Validation report form for post-registration changes for CDM project activities

VALIDATION REPORT ON POST-REGISTRATION CHANGES (PRCs)

Title and reference number of the project activity	China Yongzhou Xiangqi Hydropower Project
Process track	<input type="checkbox"/> Prior approval <input checked="" type="checkbox"/> Issuance <input type="checkbox"/> Renewal of crediting period
Version number of the validation report on PRCs	Version 01
Completion date of the validation report on PRCs	05/08/2015
Type(s) of PRCs	<input type="checkbox"/> Temporary deviations from the registered monitoring plan, monitoring methodology or standardized baseline <input type="checkbox"/> Corrections <input type="checkbox"/> Changes to the start date of the crediting period <input type="checkbox"/> Inclusion of a monitoring plan to a registered project activity <input checked="" type="checkbox"/> Permanent changes from registered monitoring plan, monitoring methodology or standardized baseline <input type="checkbox"/> Changes to the project design of a registered project activity <input type="checkbox"/> Types of changes specific to afforestation and reforestation project activities

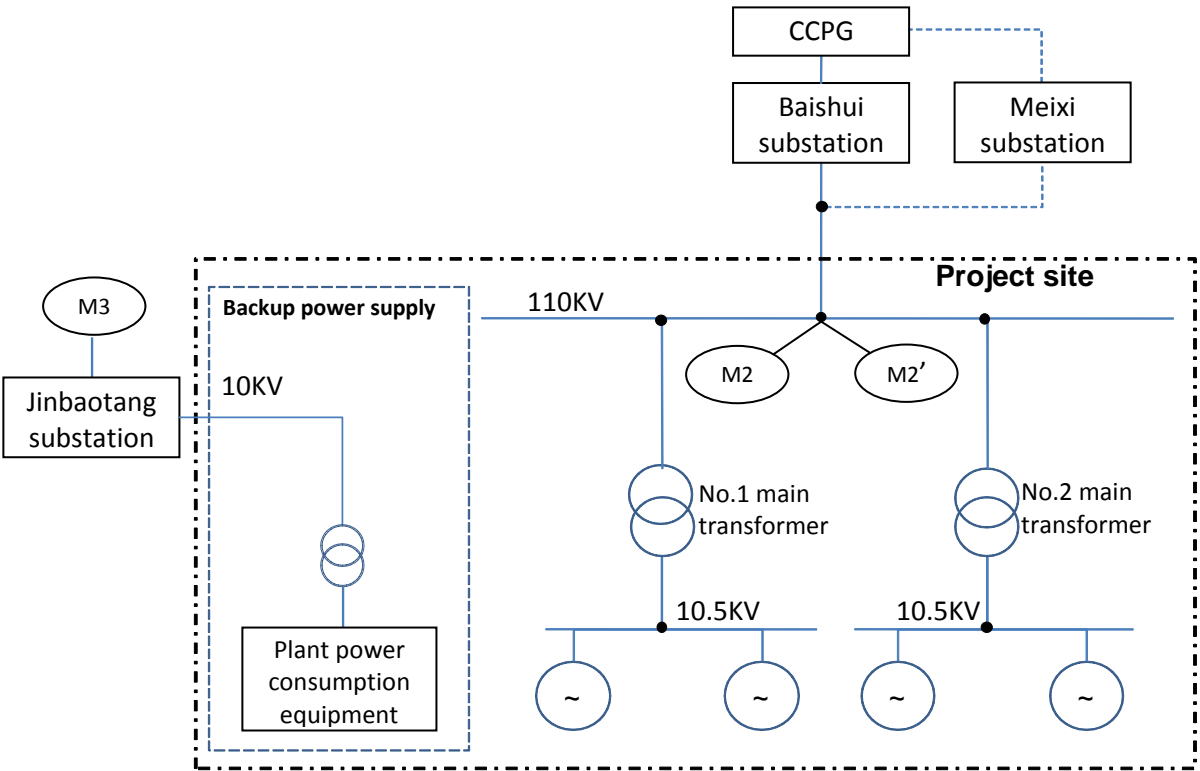
By reviewing the revised PDD version 03 /2/ and the registered PDD version 02.1 /3/, the permanent changes from registered monitoring plan are summarized as below:

In the registered PDD, there were two bi-direction main meters (M1 and M2) and two bi-direction backup meters (M1' and M2') located at the higher voltage side of each main transformer for monitoring $EG_{export,y}$ and $EG_{import,y}$, the readings of M1 plus M2 were the total quantity. And one meter M3 installed at the substation for monitoring $EG_{Emergency,import,y}$.

However, the monitoring system has been changed on 26/11/2013 /9/ by the power grid as per the Power Purchase Agreement (PPA) /7/. The meter M1 and M1' have been removed and meter M2 and M2' were relocated at the higher voltage side of the two main transformers for monitoring the total quantity of $EG_{export,y}$ and $EG_{import,y}$.

Please refer to the below diagram for an overview on how the project activity is connected to the grid, and the location of the electricity meters described above.

<p>The compliance of the permanent changes from the registered monitoring plan to the applied methodology was confirmed by review of the applied methodology ACM0002 version 13.0.0 /3/</p> <p>The validation team also compared the revised monitoring plan /2/ against the registered monitoring plan /3/, and confirmed the accuracy level of the meters was not changed, therefore the permanent changes from the registered monitoring plan do not reduce the level of accuracy of the monitoring compared with the requirements contained in the registered monitoring plan, and the changes are unlikely to lead to a reduction in the accuracy of the calculation of emission reductions.</p> <p>By reviewing the Power Purchase Agreement /7/, the validation team confirmed the permanent change to the monitoring plan is of a type described in the Project Standard Appendix 1 that does not need prior approval, since the change of location of meters are required by the Power Purchase Agreement.</p>

Findings	No findings raised in this section.
Conclusion	<p>The validation team confirms:</p> <ul style="list-style-type: none"> ✓ The permanent changes to the registered monitoring plan described in the revised PDD /2/ are in compliance with the applied methodology /5/; ✓ The permanent changes from the registered monitoring plan do not reduce the level of accuracy of the monitoring compared with the requirements contained in the registered monitoring plan, and are unlikely to lead to a reduction in the accuracy of the calculation of emission reductions; ✓ The permanent change to the monitoring plan is of a type described in the Project Standard Appendix 1 /1/ that does not need prior approval.
